FINAL VALUE ENGINEERING STUDY REPORT FOR

*113619 Brevard County
Mid-Reach Shore Protection
Project, Brevard County, Florida
(Integrated General Reevaluation Report and
Supplemental Environmental Impact Statement)*

Daft Report - September 2006
Revised Final Report - February 2010

DETAIL 1: MARINE MATTRESS, TYP.

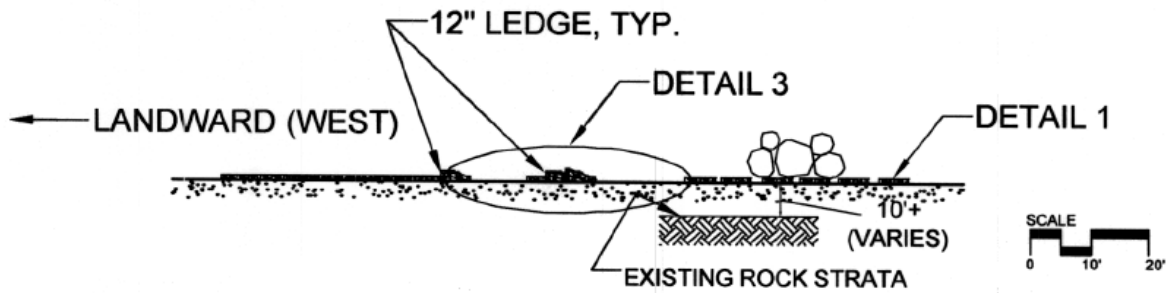
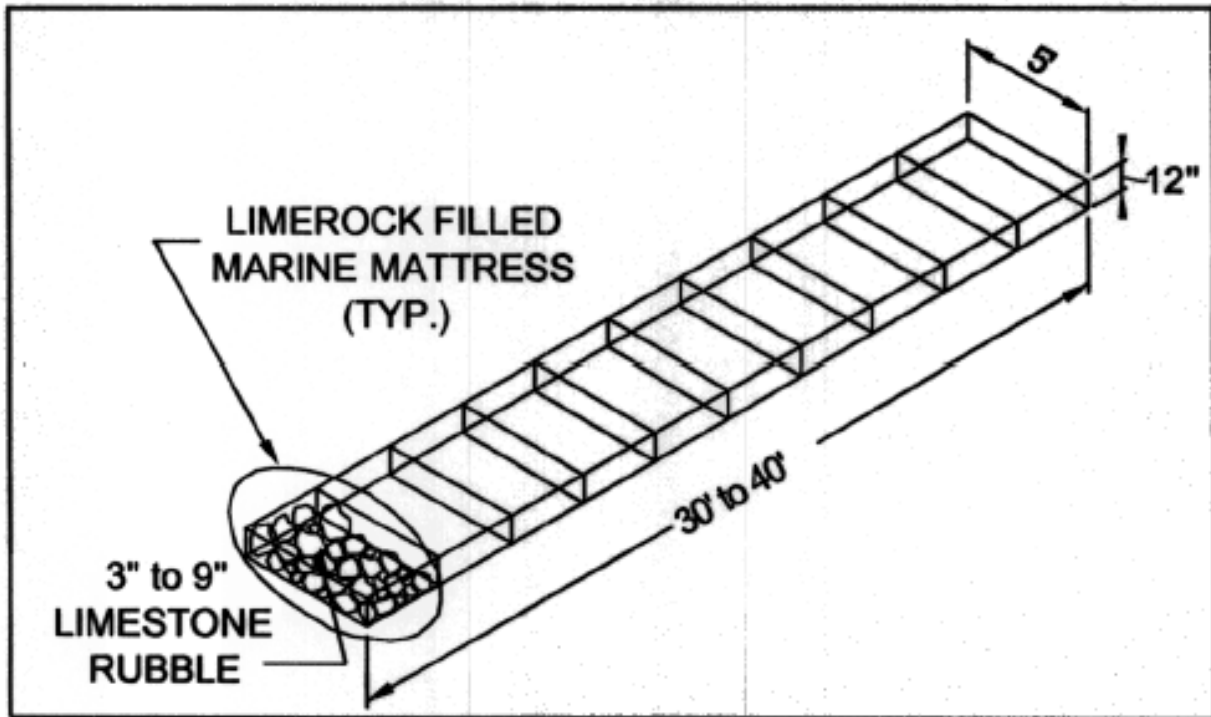
PROPOSED DESIGN: The proposed alternative mitigation reef is a formed articulated concrete mat with coquina stone imbedded in the top surface. Individual panels can be interconnected to create a large and less moveable reef. Construction of units would take place on land with placement from ocean going barges by crane. Placement depths are from 14 to 16 feet.

The proposed design may more closely mimic the natural rock formation in its low tabular structure. As such, it is possible that environmental evaluation will yield a change in the mitigation ratio. The original design requires a mitigation ratio of 3.34:1.

A quick inspection of the UMAM computation sheets shows that only one of three criteria would possibly change; that being the functionality of the mitigation reef. The reef evaluated at 3.34:1 was given a functionality of 70-75% compared to the natural reef. A modest increase to 85% would result in a change in mitigation ratio to 3.0:1. The extreme value if the functionality of the mitigation reef were assigned 100% would result in a mitigation ratio of 2.72:1. The change in construction cost with the different mitigation ratios is shown in the Cost Estimate Worksheet for this proposal.

REVISION FOR FINAL REPORT: The Recommended Plan will develop articulated concrete mats with imbedded coquina stone as the mitigation system for impacted hard ground rock. Adverse impacts to hard ground rock areas will be limited to approximately 3 acres including initial direct placement and subsequent cross-shore equilibration and long-shore diffusion.

Final details and dimensions will change with detailed design. Each articulated reef mat will contain 18 cable-connected concrete blocks with coquina surface. Mats will be about 8 FT by 15 FT by 1 FT and comprise 90 lineal feet of valleys or ridges. Approximately 42 mats will be placed adjacently with two additional top layer mats landward forming an overhang ledge. The reef mat set consists of 44 total mats to constitute 0.15- to 0.16 acres of hard bottom structure. Mitigation sites will be typically set 800 FT from existing rocks, to 1,000 FT seaward of MLW shoreline, and results in about -12 to -14 FT (MLW) water depths. Three to five mat sets spaced 50- to 60 FT apart along the -15 FT (MLW) contour will form a reef-group (0.45- to 0.75 Acres). Reef-groups would be spaced 400- to 9,000 FT apart to create the total shoreline reef mitigation.

C-1C: GRR Recommended Plan: 3 Acres Coquina-ACM Mitigation X (1.6:1 Ratio) X
\$1,209,509/Acre + 23% Contingency = \$7,141,000

Drawing 1 - Brevard County Mid-Reach LPP Plan
(GRR Recommended Plan with Beachfill Profile and Mitigation Site Shown)

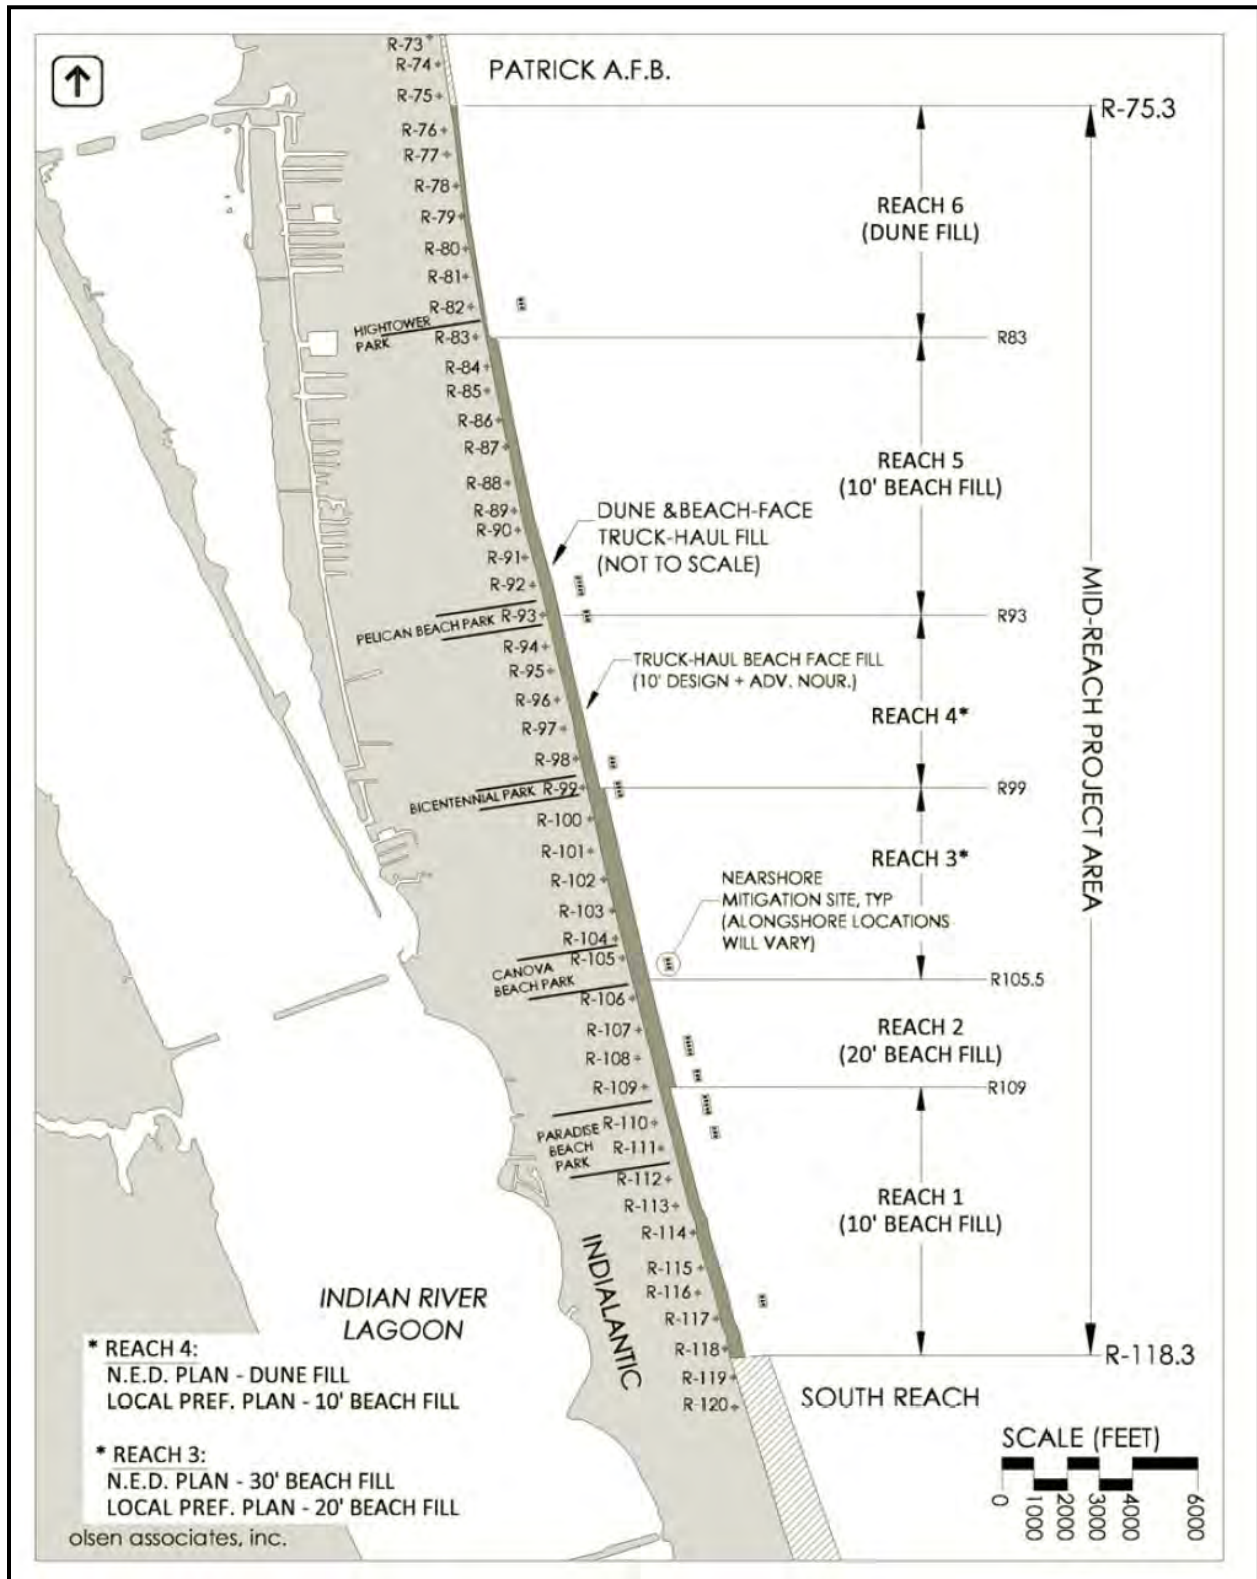
REVISION FOR FINAL REPORT: The developing plan has been greatly optimized with the development of the GRR. The Recommended Plan is the Locally Preferred Plan (LPP) which closely follows the GRR NED Plan. The difference between the two plans are changes in Reach 4 - changed from dune and vegetation only to a 10 foot beachface fill, and Reach 3 - changed from a 30 foot beachface fill to a 20 foot beachface fill with the LPP. Total sand placement is increased from 684,000 CY to 737,000 CY with the LPP. Rock impact is unchanged for the LPP.

Figure 3 presents NED and LPP plan details for optimal beach nourishment for individual Mid-Reach shoreline segments progressing from the initial VE effort to a more fully developed GRR level. The typical sections for the recommended plan are shown as Drawing 1, Mid-Reach Recommended LPP and Drawing 2, presenting respective Mid-Reach beach fill and dune fill cross sections.
